**RE: Change #7: Appendix A – Letter from VHB Regarding Visual Analysis Comments, dated December 8, 2014**

December 8, 2014  
(Revised April 7, 2015)

**Re:** Silo Ridge Response to Visual Analysis Comments

*Revisions to Redtail Pass (Road E), Ridgeline Road (Road K) and Oak Tree Lane (Road Q)*

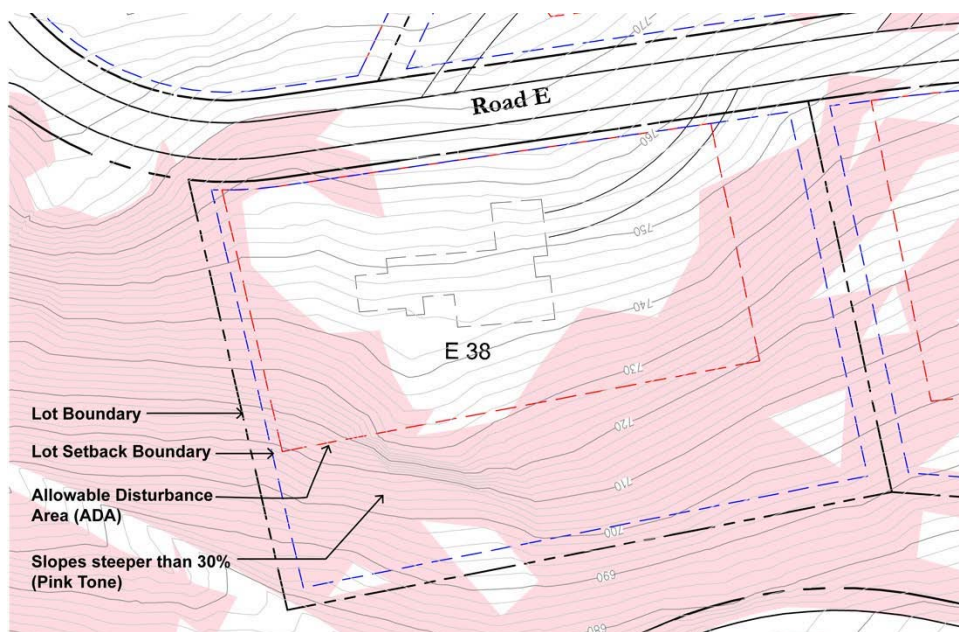
In response to comments, the design of the roads and lots in the Estate Home area has been refined. This refinement reduces grading impacts and tree removal, and better situates proposed improvements in the natural setting. Cumulatively, these refinements reduce potential visual impacts. Specifically:

The alignments of these roads have been modified to better fit the land and reduce grading impacts and associated tree removal. Further, retaining walls are now proposed in certain areas to reduce grading impacts. This allows for more existing trees to be retained, which provides additional screening for the proposed improvements.
